3/4.9.12 SPENT FUEL ASSEMBLY STORAGE

SAFETY EVALUATION
FOR INCREASING THE FUEL ENRICHMENT LIMIT
AT THE VIRGIL C. SUMMER NUCLEAR STATION
TO 5.0 W/O U-235

With this Technical Specification change request, South Carolina Electric & Gas Company (SCE&G) is proposing to:

FIGURE 3.9-1 MINIMUM REQUIRED FUEL ASSEMBLY BURNUP AS A FUNCTION OF INITIAL ENRICHMENT TO PERMIT STORAGE IN REGION 2

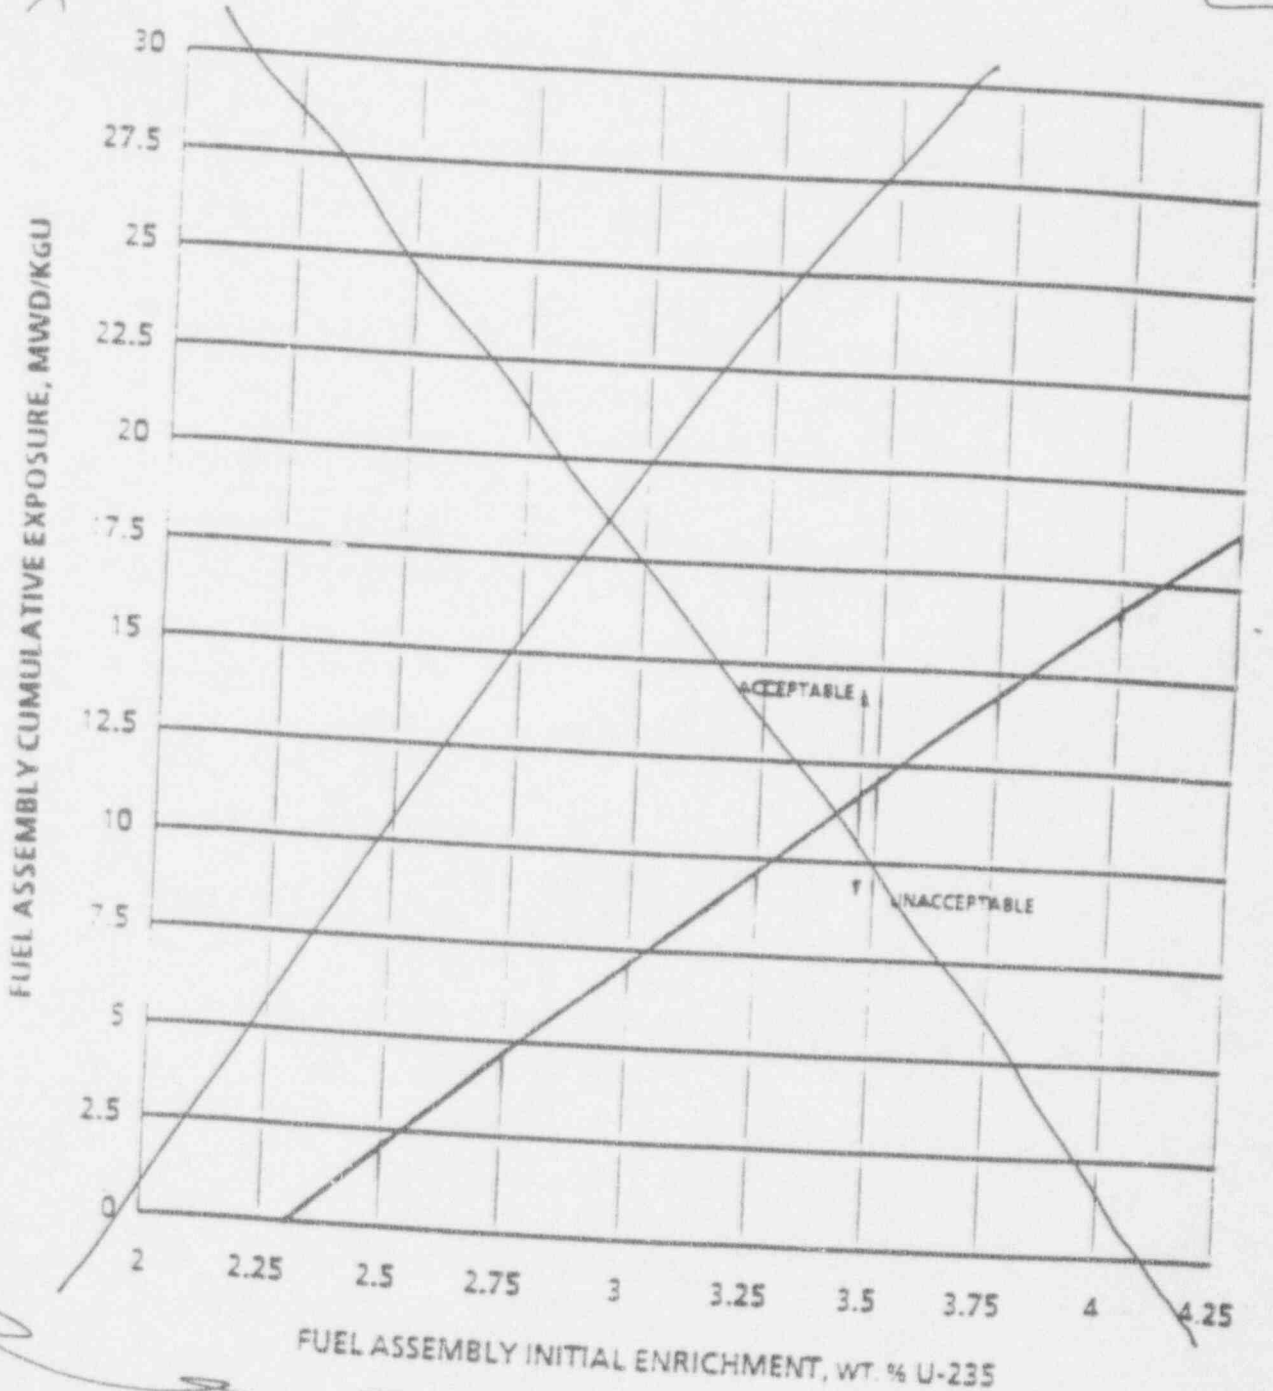
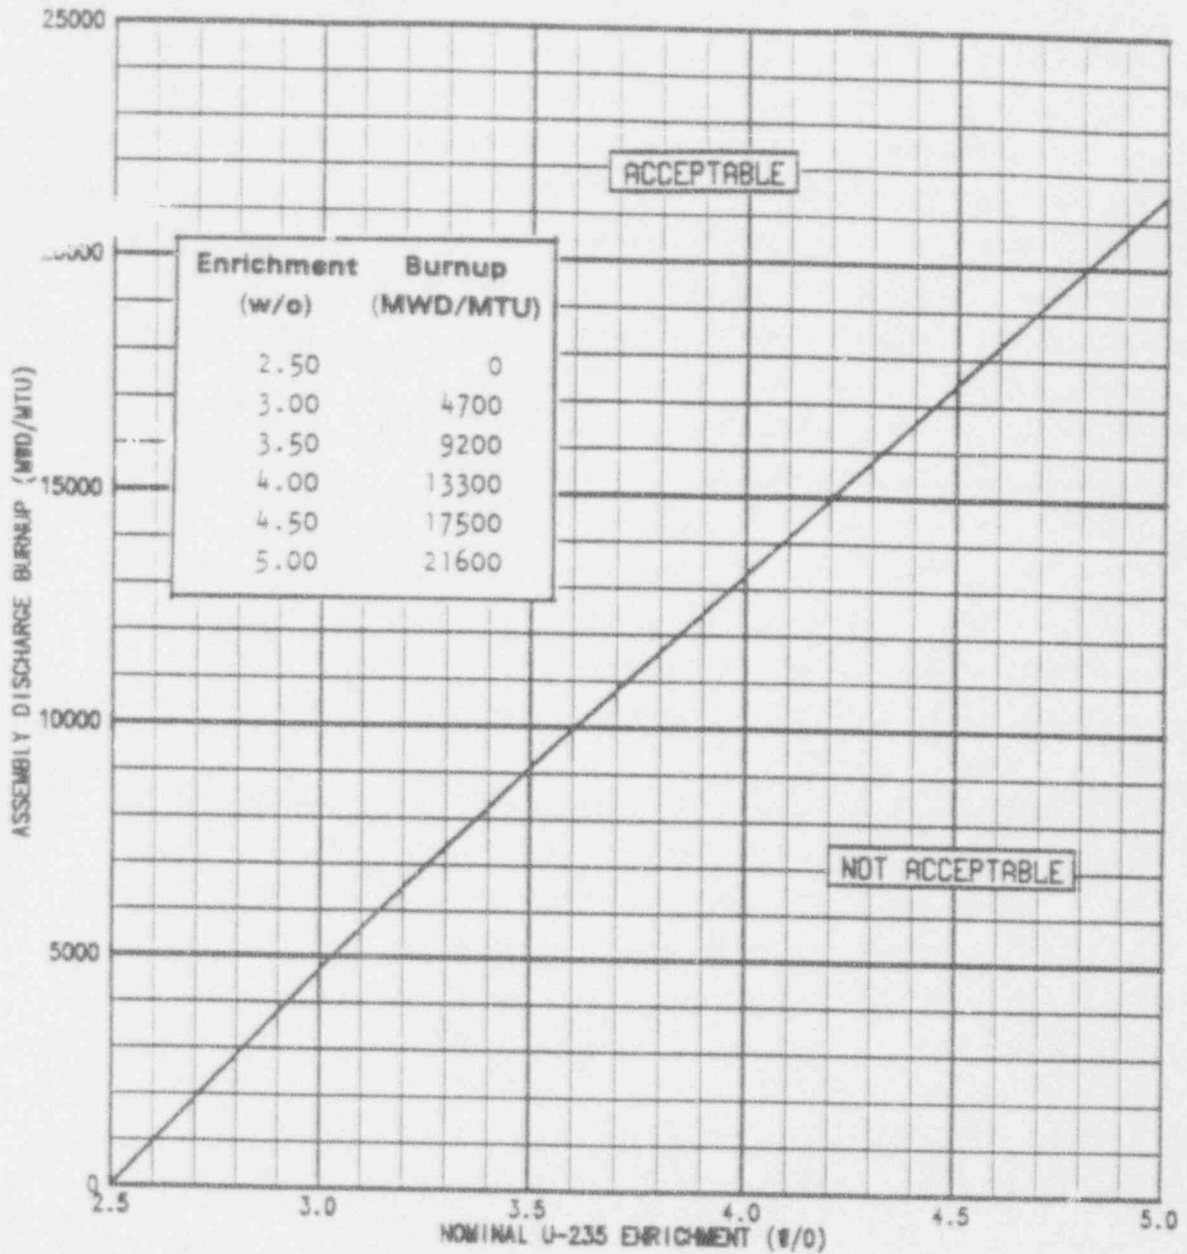
FIGURE 3.9-1 MINIMUM REQUIRED FUEL ASSEMBLY ^{BURNUP} EXPOSURE AS A FUNCTION OF INITIAL ENRICHMENT TO PERMIT STORAGE IN REGION 2

2. Extend the restrictions in Specification 3.9.12 on cumulative fuel burnup as a function of initial enrichment for fuel stored in Regions 2 and 3 of the spent fuel pool to 5.0 w/o U-235. The burnups required for storage in Region 2 have also been revised to account for the presence of absorber panel shrinkage and gaps, as described in Attachment IV (Region 3 does not contain absorber panels.). Note however that the use of the measured 95/95 minimum B-10 loading of 0.0033 gm/cm² in the Region 2 absorber panels in the attached criticality re-analysis rather than a minimum 0.0015 gm/cm² used in the previous criticality analysis (Reference 1) resulted in a net

Note: The use of linear interpolation between the minimum burnups reported above is acceptable.

FIGURE 3.9-2 MINIMUM REQUIRED FUEL ASSEMBLY BURNUP AS A FUNCTION OF INITIAL ENRICHMENT TO PERMIT STORAGE IN REGION 3

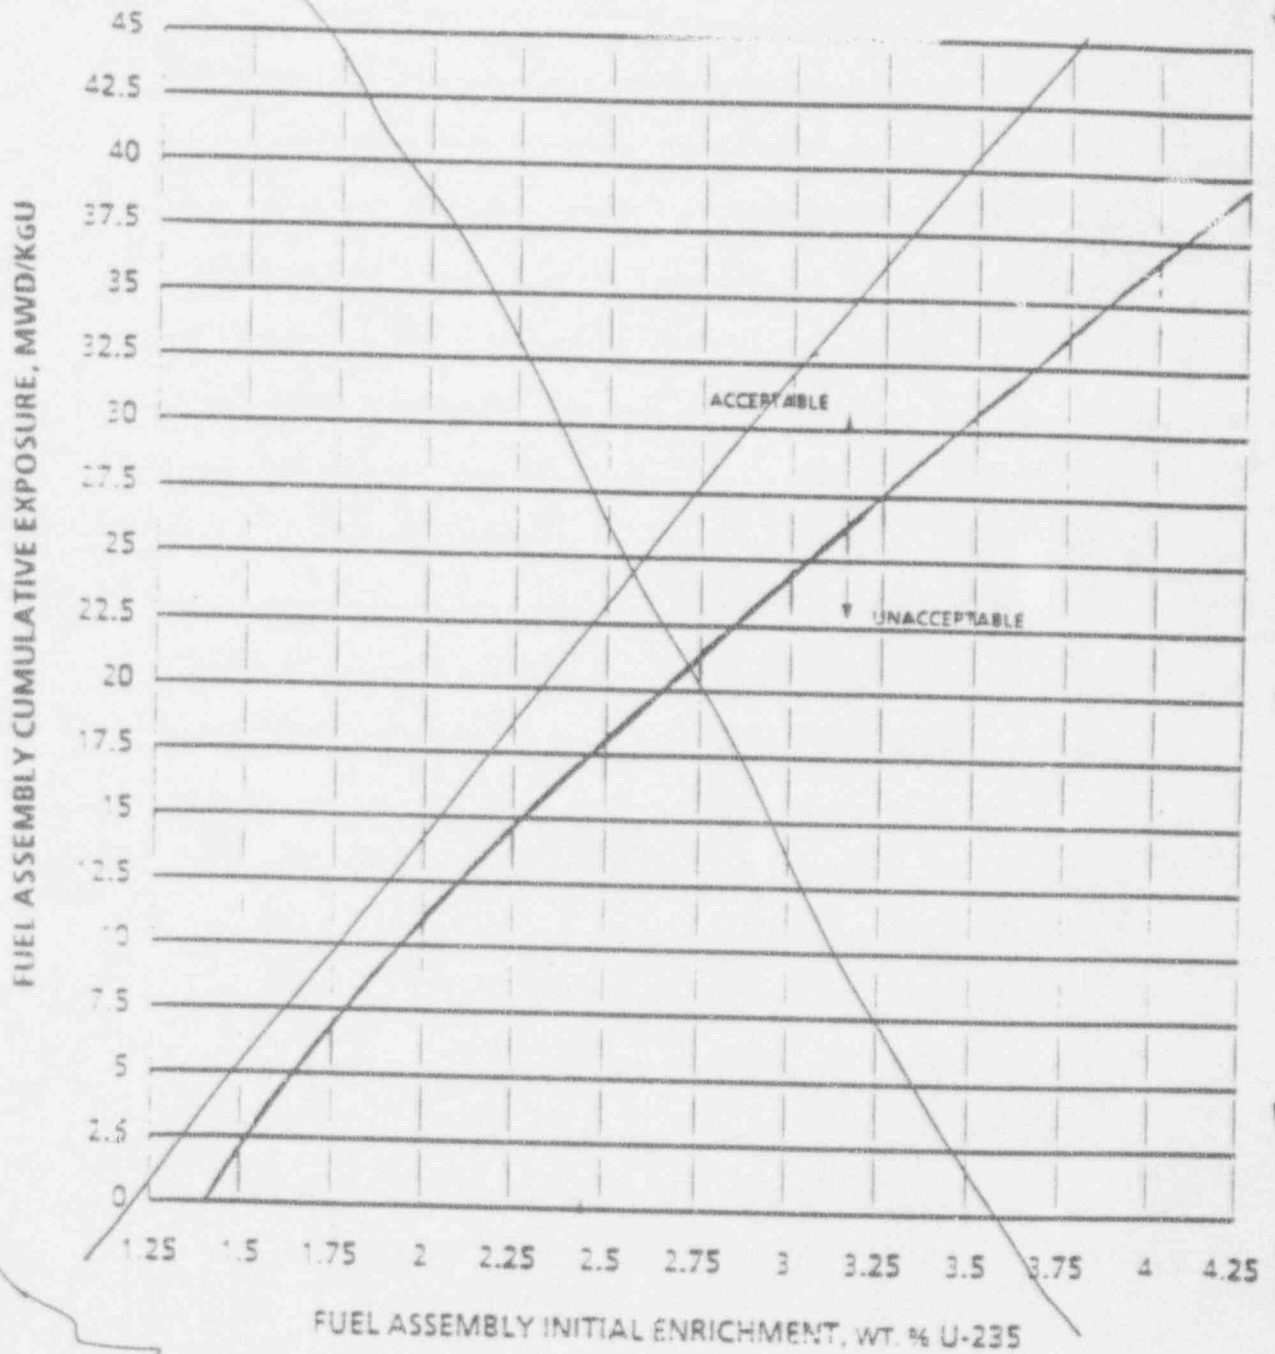
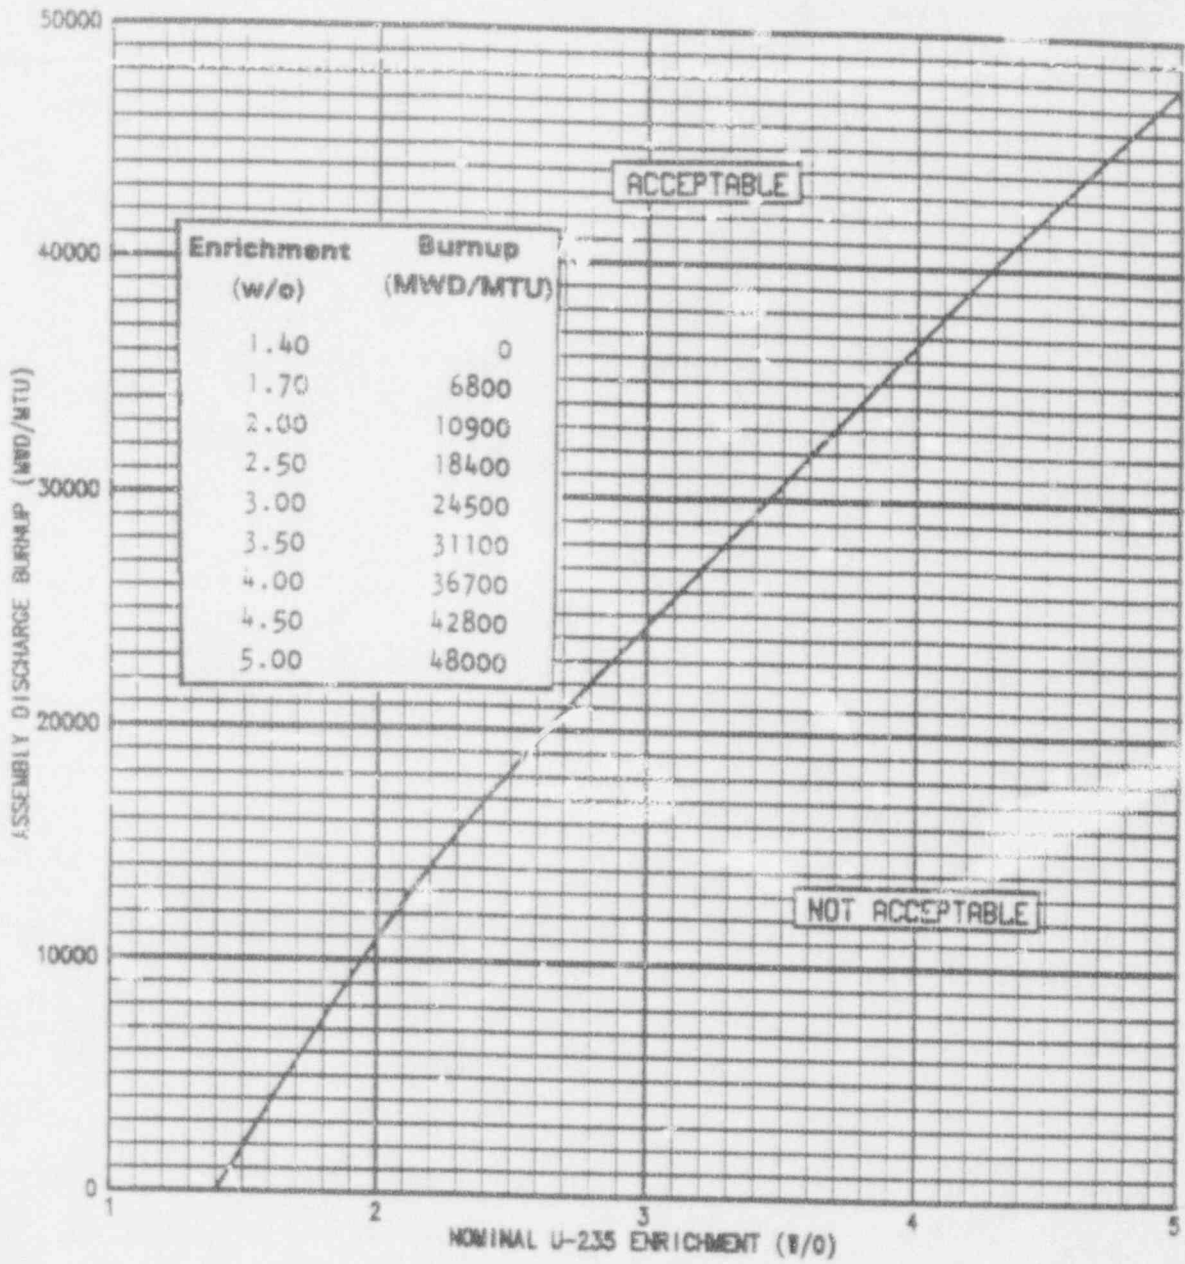
BURNUP
FIGURE 3.9-2 MINIMUM REQUIRED FUEL ASSEMBLY EXPOSURE AS A FUNCTION OF INITIAL ENRICHMENT TO PERMIT STORAGE IN REGION 3

1. New and freshly discharged fuel assemblies with a maximum nominal enrichment of 5.0 w/o U-235 may be stored in Region 1. Fuel assemblies stored in Region 1 must contain sufficient integral fuel burnable absorbers such that the maximum reference fuel K_{∞} is less than or equal to 1.460 at 68°F.
2. Fuel assemblies with a maximum nominal enrichment of 2.5 w/o U-235 with no burnup and up to 5.0 w/o U-235 with a minimum burnup of up to 21,600 MWD/MTU, as specified in proposed Technical Specification Figure 3.9-1, may be stored in Region 2.
3. Fuel assemblies with a maximum nominal enrichment of 1.4 w/o U-235 with no burnup and up to 5.0 w/o U-235 with a minimum burnup of up to 48,000 MWD/MTU, as specified in proposed Technical Specification Figure 3.9-2 may be stored in Region 3.

Note: The use of linear interpolation between the minimum burnups reported above is acceptable.
